Village of Celoron Lucille Ball Memorial Park Sea Wall and Boardwalk Phase 1

Addendum #2

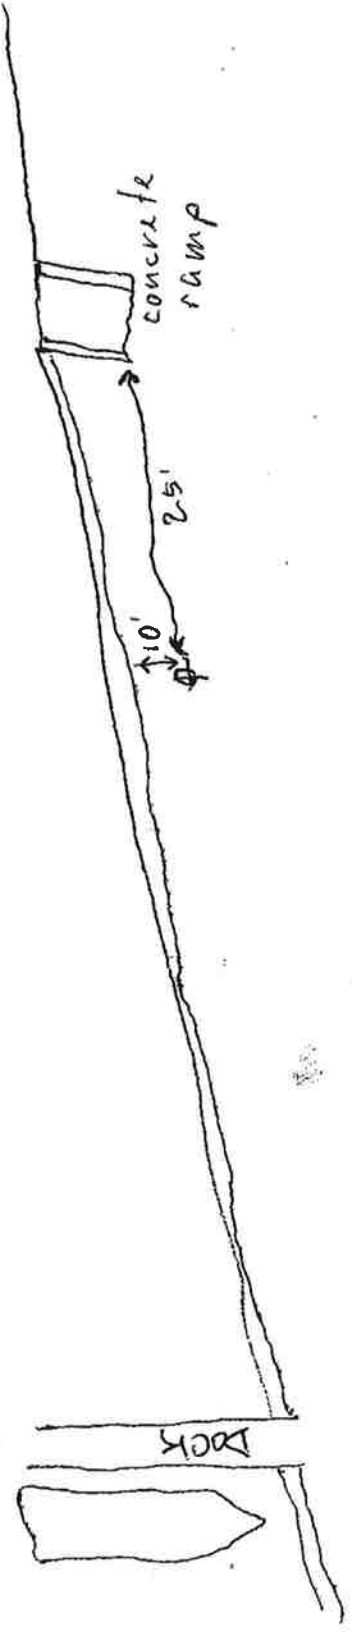
1. Attached the soils boring log B-1 which is provided for information purposes only.
2. Blended NYSDOT No.1 & No.2 Stone is acceptable backfill for the stone columns.
3. The Specification identifying 3.5 ft. average effective diameter for the stone aggregate piers governs.
4. The intent of the design of the aggregate columns is to bear on the clayey silt layer at a depth of 28 ft.. Field conditions may dictate the need for shorter or longer columns.
